CERTIFICATE OF APPROPRIATENESS

Applicant: Karen Brasier, Design 3 Studios, for Lucas and Brooke Brown, owners

Property: 642 Columbia Street, Lot 23, Block 281, Houston Heights Subdivision. The property includes a noncontributing 2,086 square foot, one-story wood frame brick clad single family residence and one-story detached garage situated on a 6,600 square foot (50' x 132') interior lot.

Proposal: New Construction – (Revision) Alter the fenestration design from a decorative divided 9-over-1 configuration to a divided 3-over-1 configuration. The proposed residence will also be shifted 5” to the south. Additionally, the window trim will be altered to be more decorative and the decorative porch posts will be simplified.

WEST ELEVATION – FRONT FACING COLUMBIA STREET

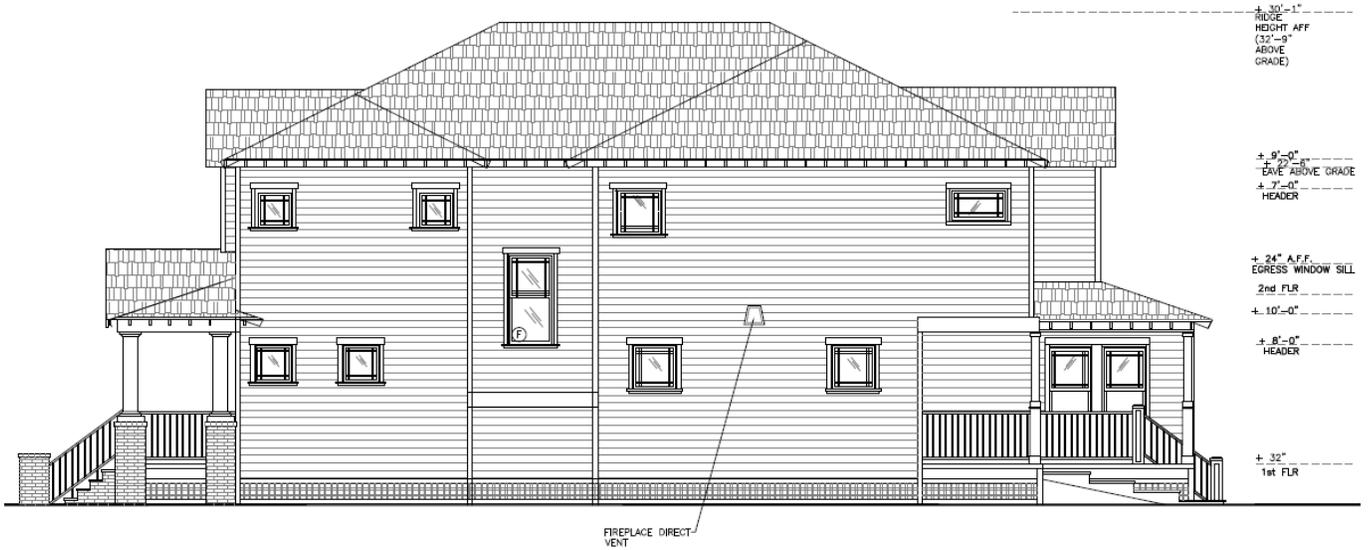
02-26-2015: The revised proposal will have a combination of double hung and fixed wood windows. A single vinyl fixed window is also proposed. All windows on the front and side elevations will feature a decorative 3-over-1 lite pattern. The proposed front door will have Craftsman detail. The location, number, and size of windows will be altered from the original proposal. See drawings and windows schedule for more detail.

02-26-2015: The front elevation of the revised proposal will not be altered. See drawings for more detail.

SOUTH SIDE ELEVATION

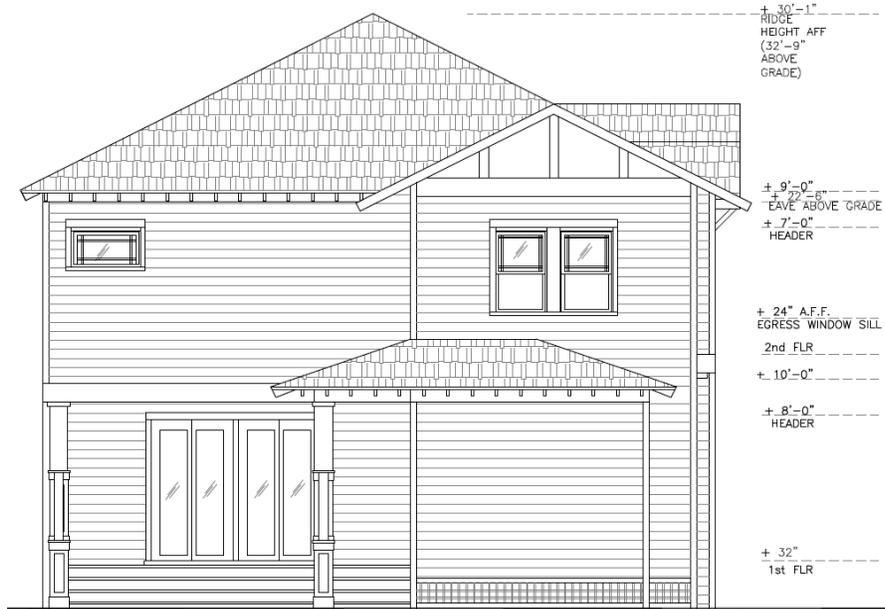
02-26-2015: The western portion of the south elevation of the revised proposal will include two square fixed windows on the second story. To the east, an inset portion will include a single double hung window. The eastern portion will project out and include two square fixed windows on the first story and two fixed windows on the second story. A rear porch includes an additional pair of double hung windows. See drawings for more detail.

WEST (REAR) ELEVATION
APPROVED (JANUARY 29, 2015)

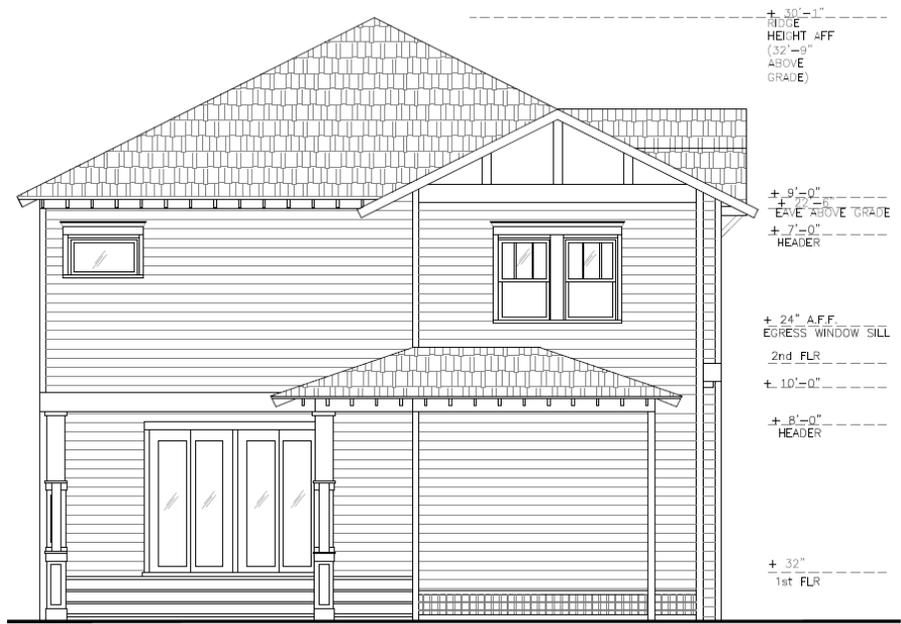
02-26-2015: The north elevation of the revised proposal will not be altered. See drawings for more detail.

02-26-2015: The proposed revisions to the rear elevation of the residence will not visible from the public Right-of-Way. See drawings for more detail.

ROOF PLAN

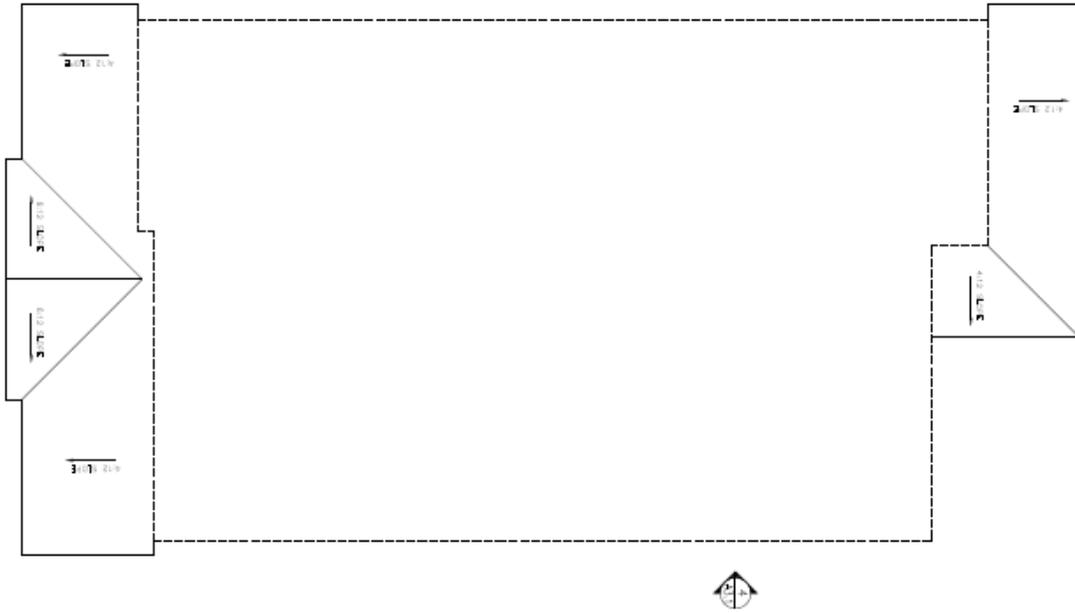
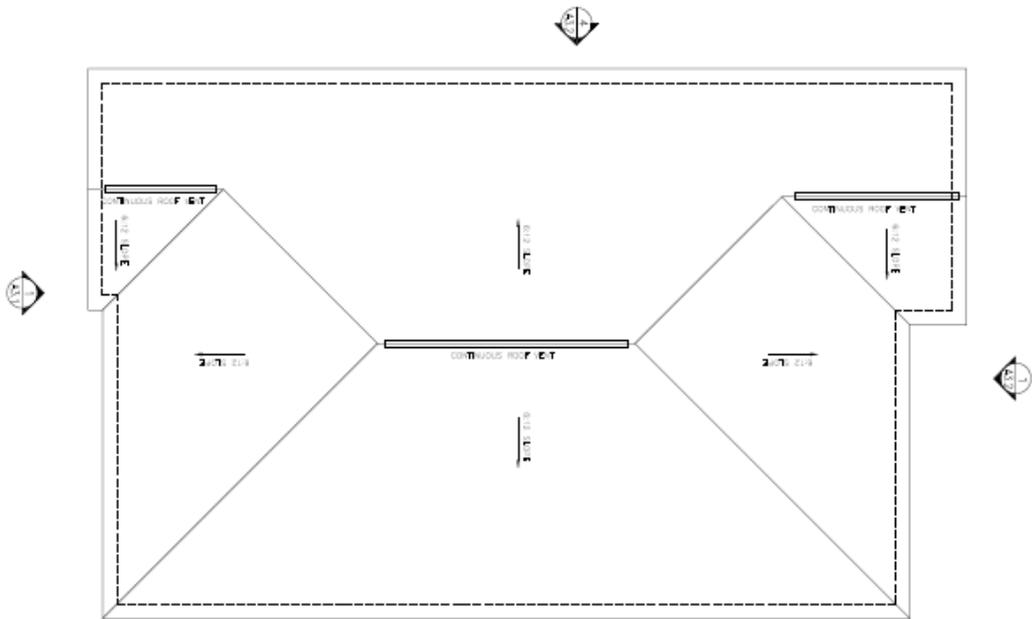
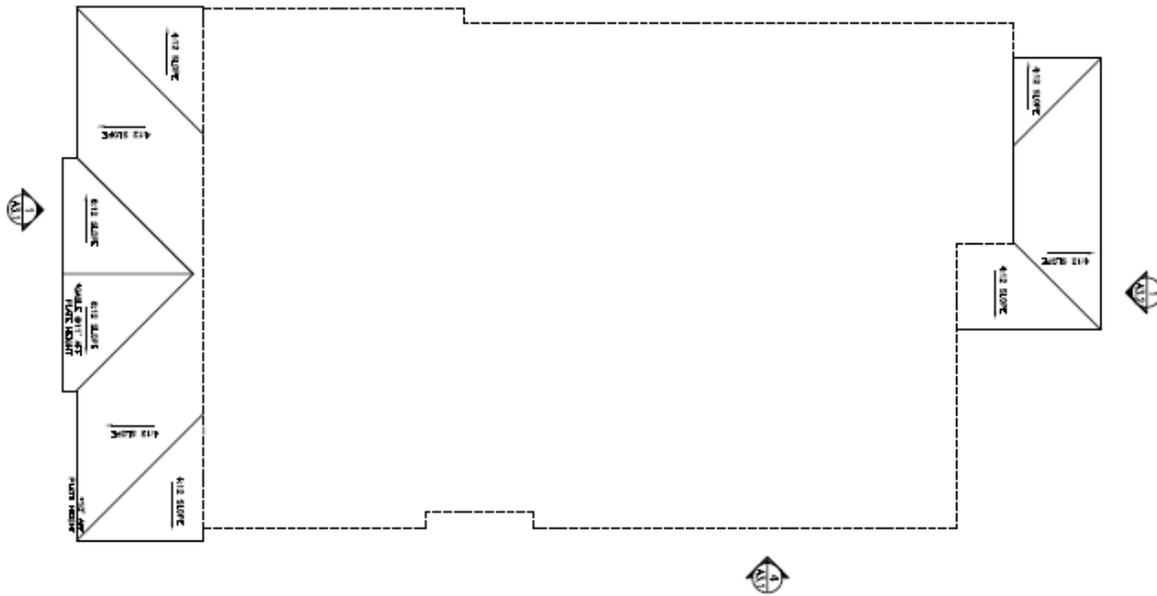
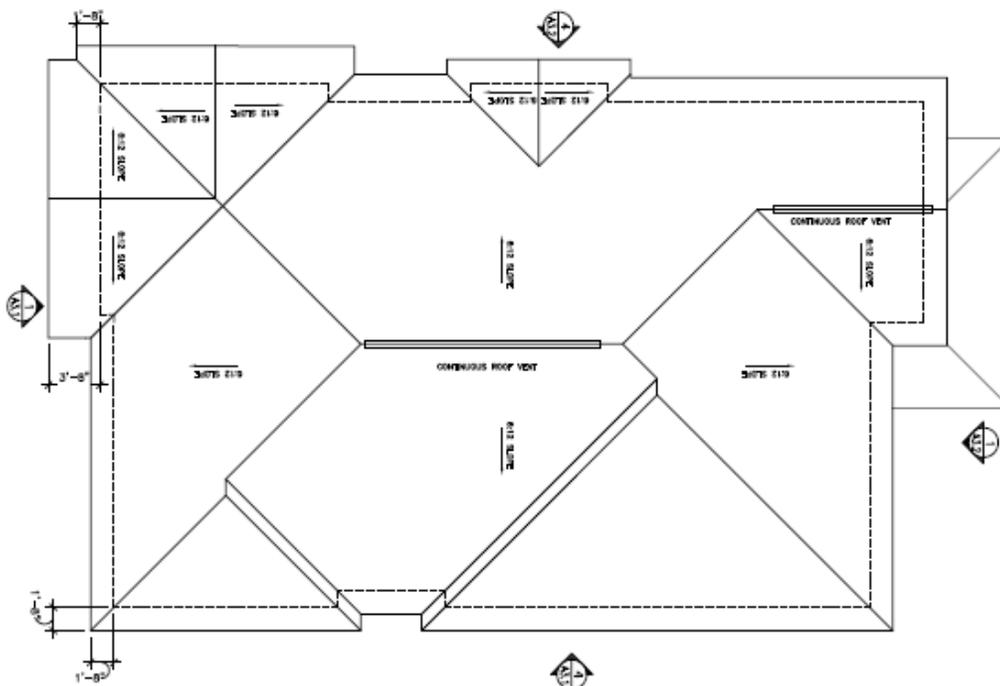
02-26-2015: In the revised proposal, the proposed residence will be shifted 5" to the south. The revised proposal will have a north setback 10'-6" and a south setback of 3'-2". See drawings for more detail.

02-26-2015: The roof of the revised proposal will not be altered. See drawings for more detail.
